SERVICE ADVISORY # 14-212

Kodiak Front Bed

It has been determined Kodiak model 220RBSL were built with a fold down front bed which is inadequately supported for its intended use. This service advisory explains how to replace the front bed platform.

Models Included: 2014 Kodiak 220RBSL

Fig. 7

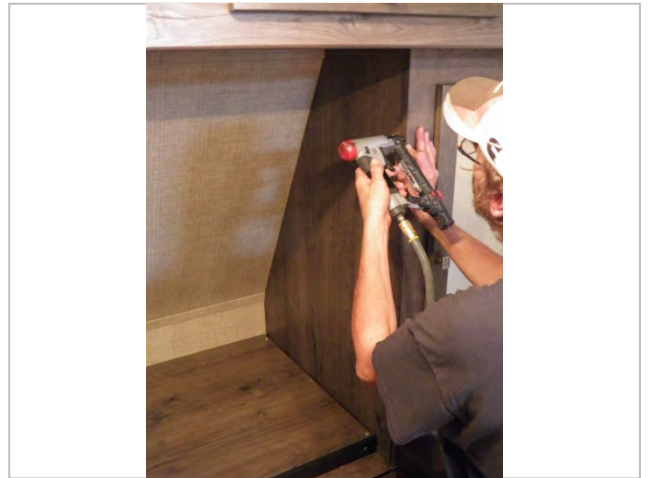
Measure the height of the wardrobe cabinets (Figure 7) and cut a piece of the supplied flat trim for each cabinet. Fasten one piece of trim on the front inside edge of each wardrobe and use putty (Thoreau Cherry) to fill the staple holes (Figure 8).

Fig. 9

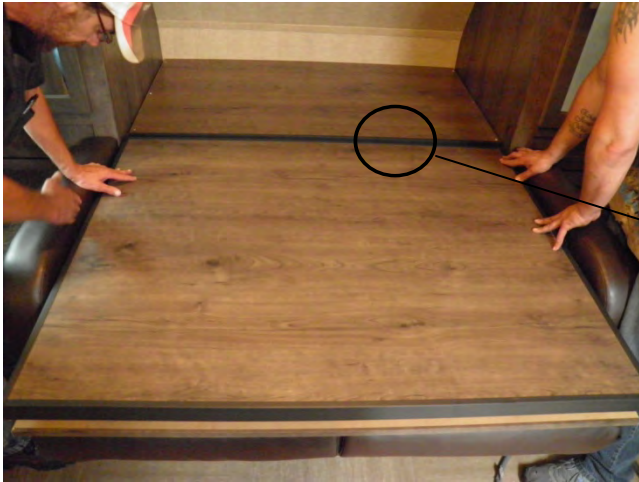
Step 1 Place the bed platform on the sofa (Figure 9). Center the platform between the sofa arms and spaced 2 1/8" away from the cabinet (Figure 10). Screw the bed platform hinges to the cabinet.

Fig. 13

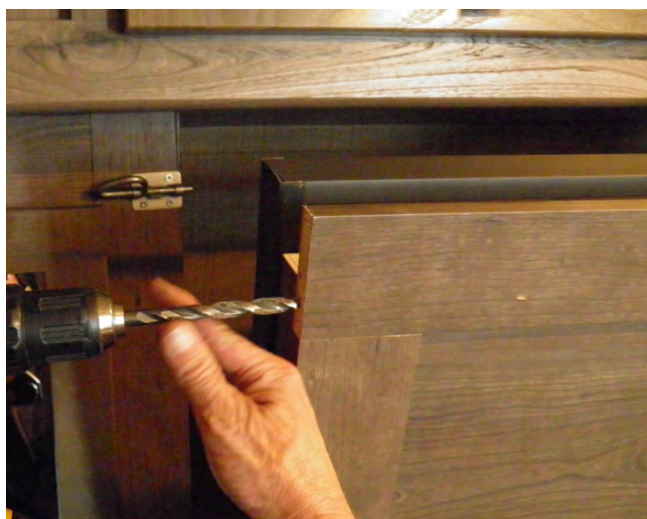
Step 2 Aligned the latch and catch assembly with the cabinet face and the bed platform (Figure 11). Secure one latch to the cabinet face then mark the edge of the bed platform to locate the catch (Figure 12). Drill a 3/8 Diameter by 1" deep hole into the edge of the bed platform (Figure 13) to allow the latch to function. Secure the catch plate to the bed platform (Figure 14). Repeat for the other side.
